# Prairie Island Independent Spent Fuel Storage Installation

**License Renewal Application**

Discussion of Requests for Additional Information

Rockville, Maryland June 16, 2014

# ANNOTATED PHOTOGRAPHS FROM CAP #01291889 CASK #1 BOTTOM INSPECTION

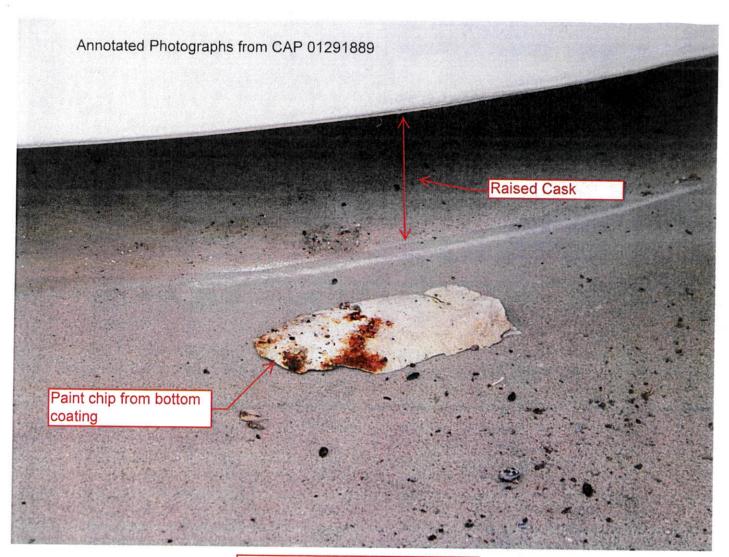
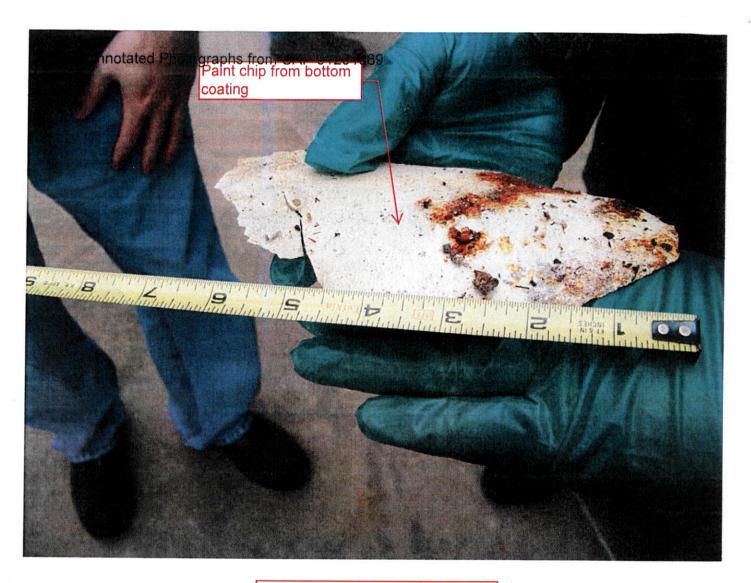
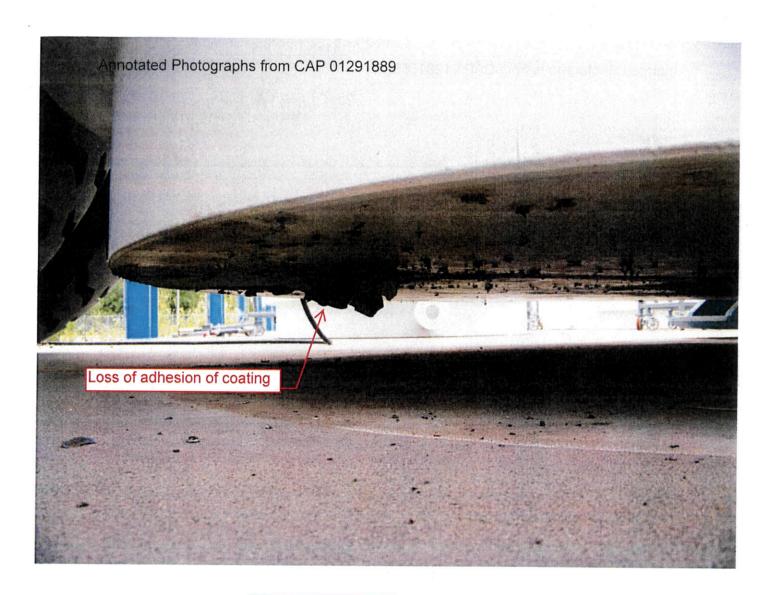
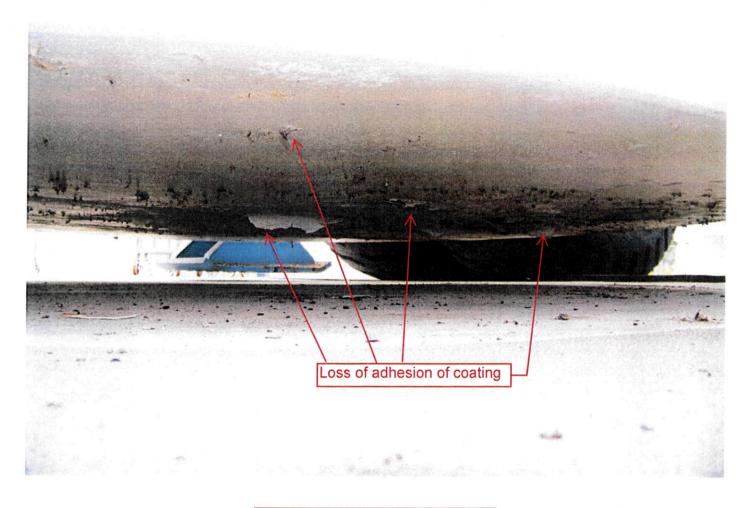
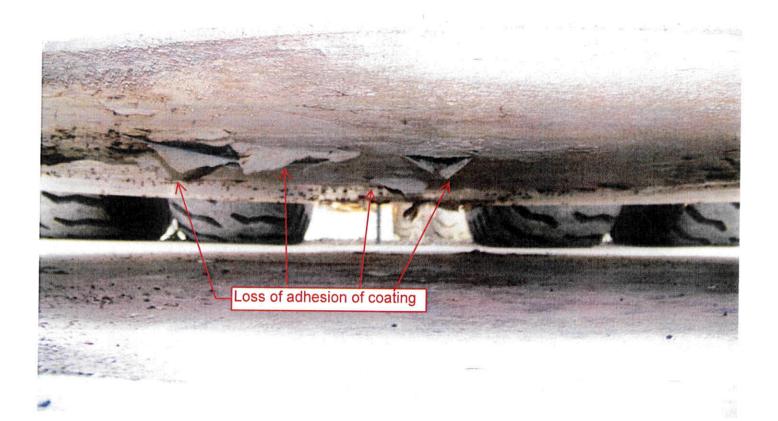
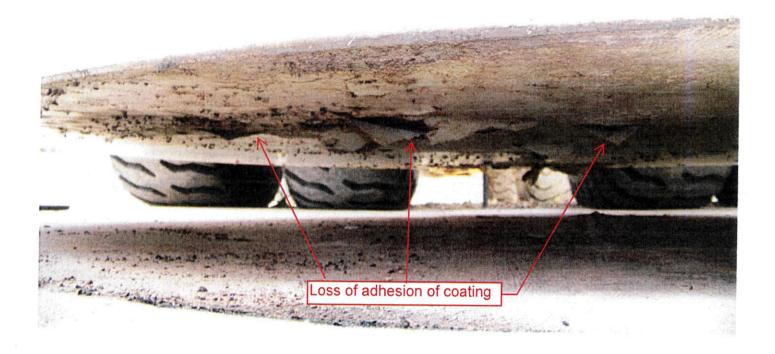
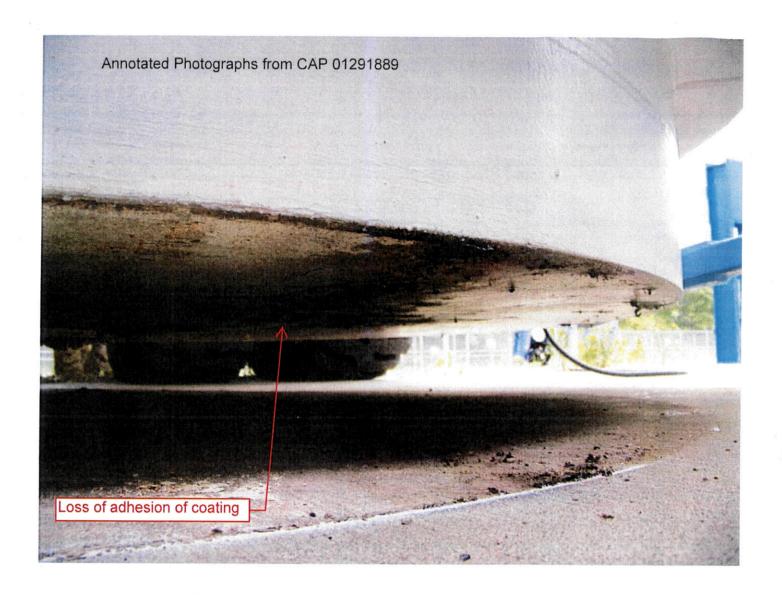
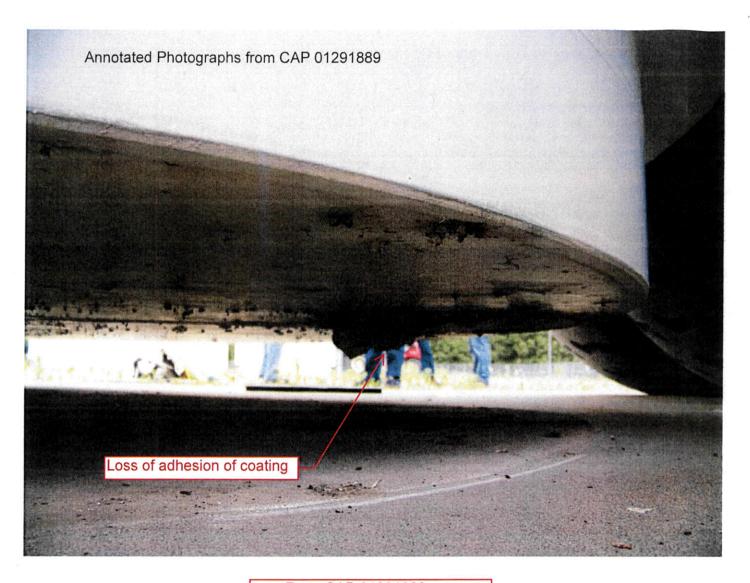
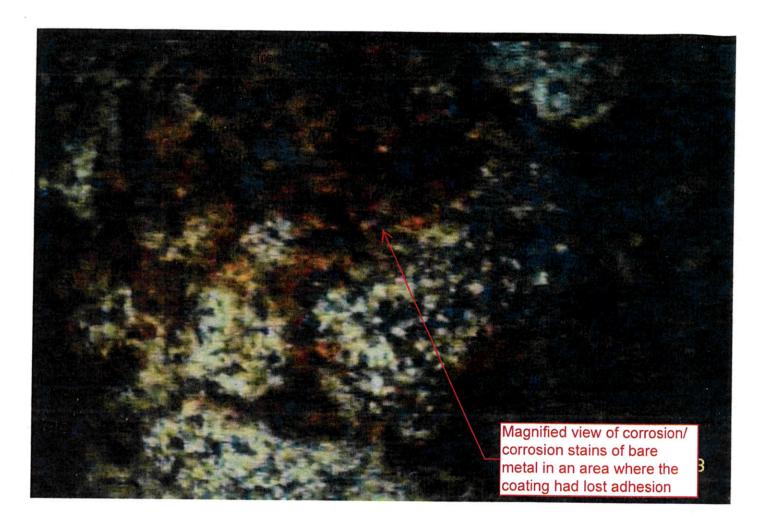
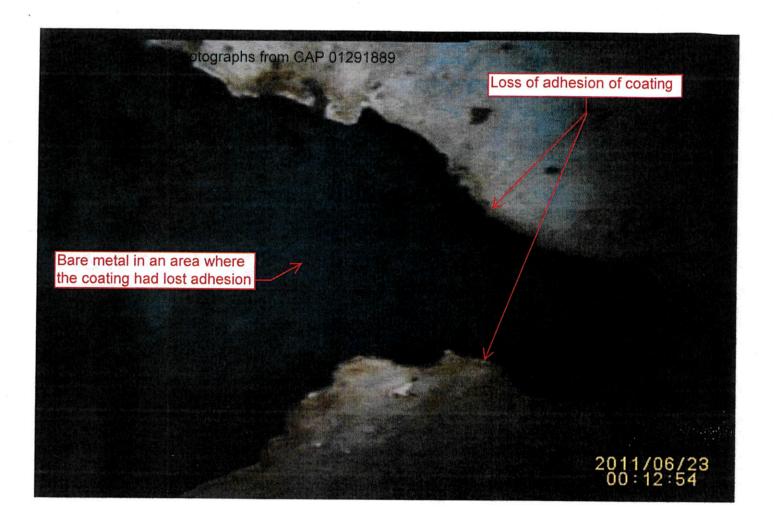
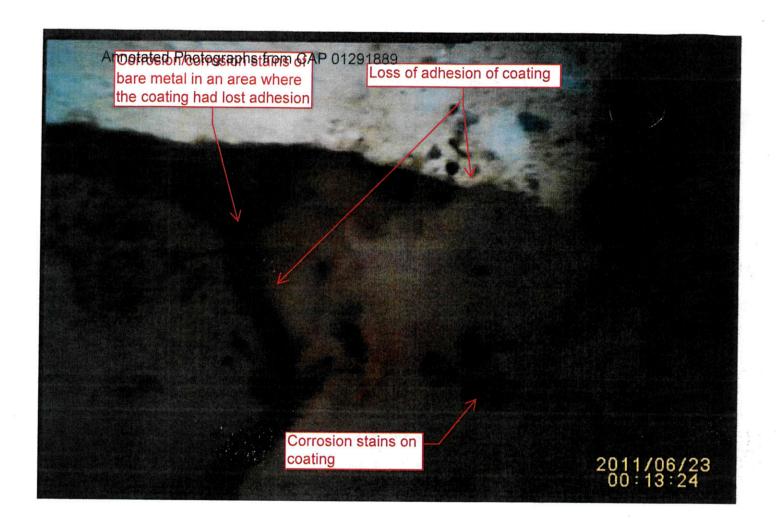
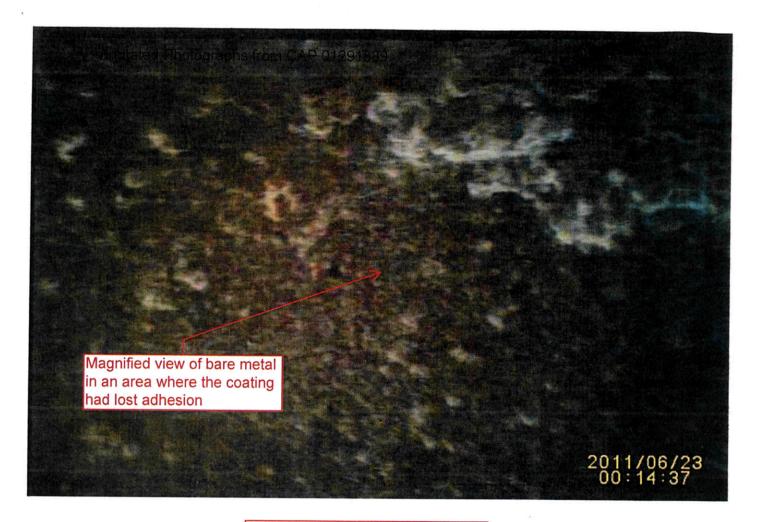
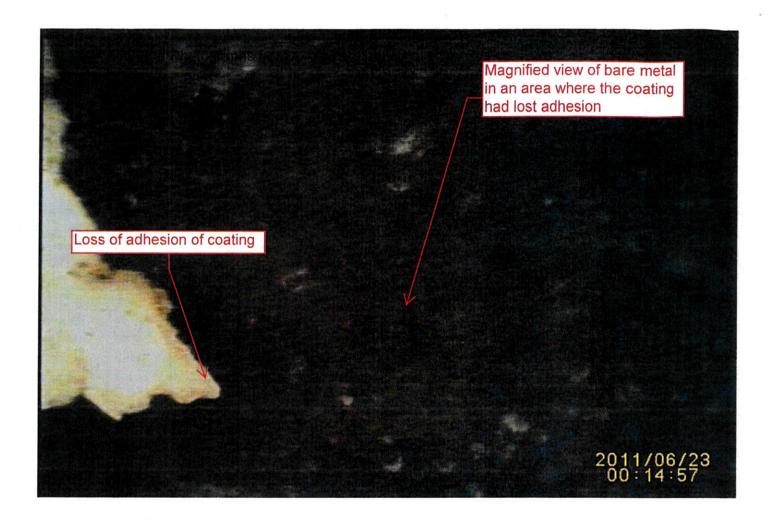
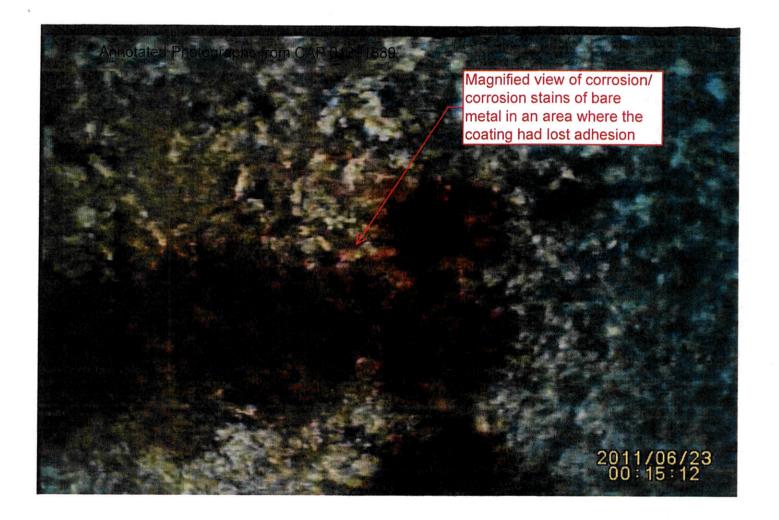
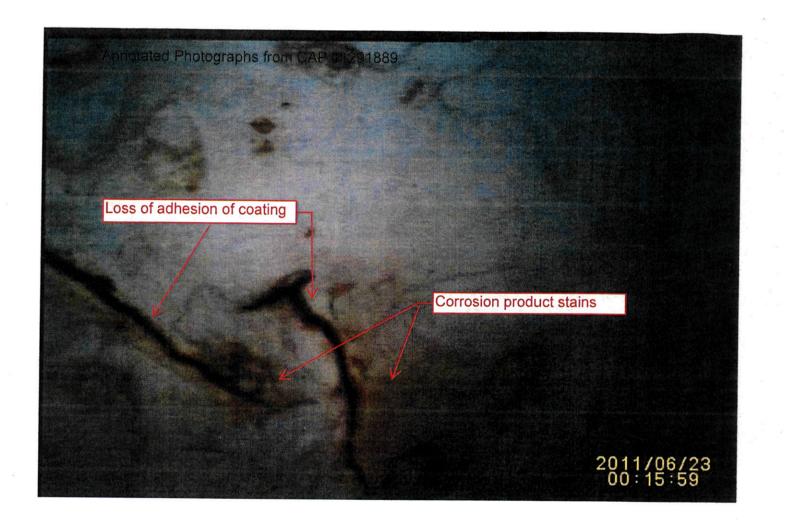
Provide conclusive evidence to support no observable loss of material statement regarding the lead cask examination. Also, clarify photographs of the inspection and address observations regarding pits and measurable loss of material.

- Use of visual examinations is consistent with NUREG 1927, Appx E, Component Specific Aging Management
- Only "conclusive evidence" is inspection report with documented observations by the inspector
- Inspector documented no observable depth to corrosion (including pitting corrosion)
- AMP will be revised to clarify "no measureable loss of material" should be "no observable loss of material"
- Discussion of photos and annotations
